MERCURY Racing parts bulletin MERCURY MerCruiser

No. 99-2

P/N 16413A 3 and P/N 16413A 9 V6 and V8 Thermostat Housings Ordering Information

P/N 16413A 3 With Check Balls

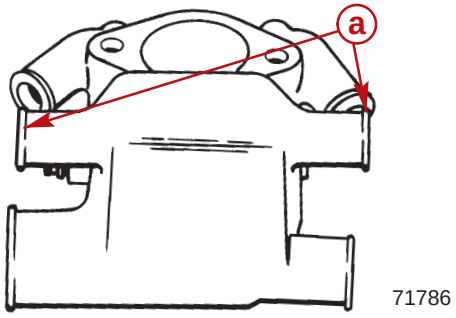
The 2 thermostat housings shown below are no longer available. The casting is not available from our supplier.

Before ordering replacement kit, look at the location of the threaded holes in the intake manifold as shown below. V6 and V8 305/350 cid engines have the threaded holes at 90º from the crankshaft centerline while the 454/502 cid Mark IV and Gen V engines are not. This new kit contains the older style thermostat housing that used the brass 'Tee' fitting with check balls.
